DEVELOPMENT REVIEW COMMITTEE (DRC) COMMENT REPORT

PROJECT NAME: 1201 E Las Olas

CASE NUMBER: R18002

Site Plan Level II Review: 6,918 Square Feet of

Existing Stormwater Asset Map possibly affected by the Proposed Development

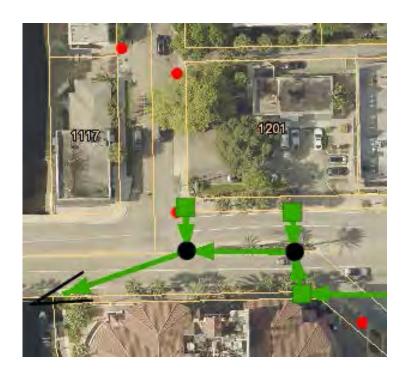
The City owns and maintains stormwater infrastructure adjacent to the proposed development as shown with green line work in the map provided at the end of this report. The following comments pertain to possible impacts of the proposed development and/or construction activities to the existing condition of the City's stormwater assets. The applicant shall provide an itemized response letter addressing the following comments:

1. Please provide (or revise if already submitted) an erosion, sedimentation, and stormwater pollution prevention plan (SWPPP) showing the adjacent City's existing stormwater system as shown in the survey and to the limits shown with green line work in the storm map provided at the end of this report. A copy of the approved SWPP shall be at the construction site from the date of demolition initiation to the date of final construction activities.

- a) Contractor shall provide CCTV videotapes to City STW OPS of the existing stormwater system (and gravity sewer pipe in the alleyway) to the limits shown with green line work in the storm map provided at the end of this report in order to document the PRE and POST construction conditions of the City's systems.
